Product/Process Change Notice (PCN)

PCN Number: PCN_WCAP-AIG8_20250707 Affected Series: WCAP-AIG8 Affected Part Number: see table below PCN Date: 2025-04-07 (YYYY-MM-DD) Effective Date: 2025-07-07 (YYYY-MM-DD)	Change Category: ☐ Equipment/Location ☒ General Data ☐ Material ☐ Process ☐ Product Design ☒ Shipping/Packaging ☐ Supplier ☐ Software
Contact: Product Management Phone: +49 (0) 7942 - 945 5001 Fax: +49 (0) 7942 - 945 5179 E-Mail: pcn.eisos@we-online.com	Datasheet Change: ☒ Yes ☐ No Attachment: ☐ Yes ☒ No

Because of a database mismatch, Würth Elektronik eiSos will correct the electrical and mechanical characteristics in the datasheet. Furthermore the packaging will be changed.

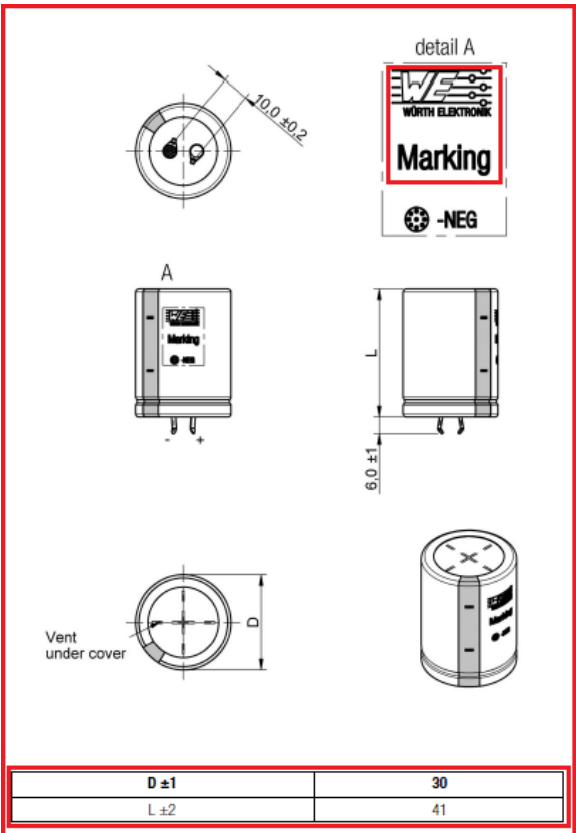
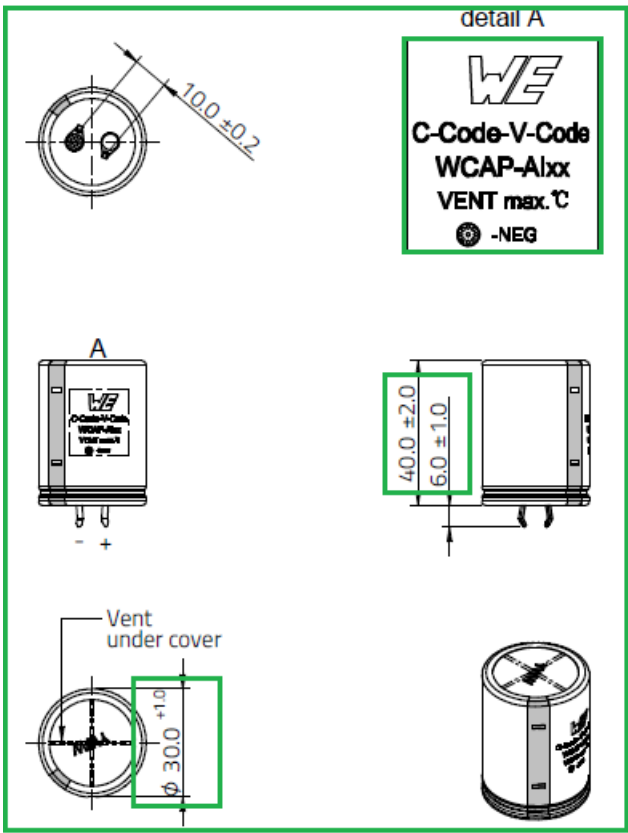
1.1 Würth Elektronik will update the dimensioning from an **indirect dimensioning** to a **direct dimensioning**.

The table will be removed and all dimension values will be shown directly in the drawings. And marking in the drawing will be described more precisely.

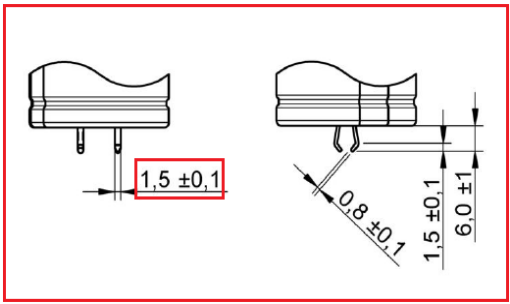
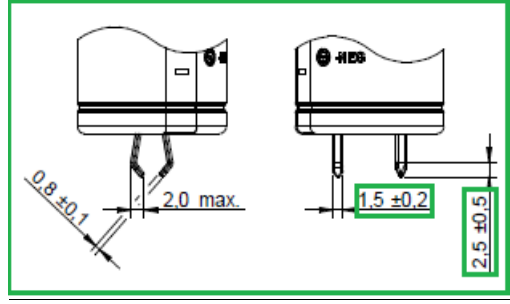
1.2 **Tolerance of Pitch** will be corrected from "10±0.5 " into " 10±0.2" for below part numbers.

Before Change	After Change
10 ± 0.5 mm	10 ± 0.2 mm
